Meeting Minutes

Bryant PG Play Area Renovation – Meeting #1

October 18, 2023

Basketball

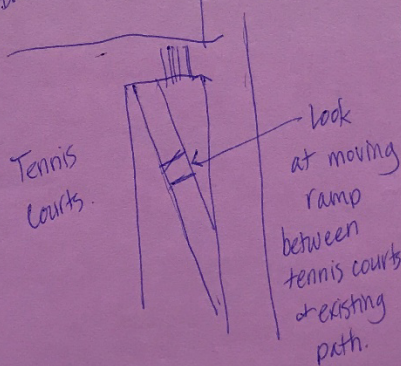
Freeplay/Frisbee area is needed as it is keep trees out of this area.

Swings in this location are problematic - 100% potential for collision between kids playing in field & swings.
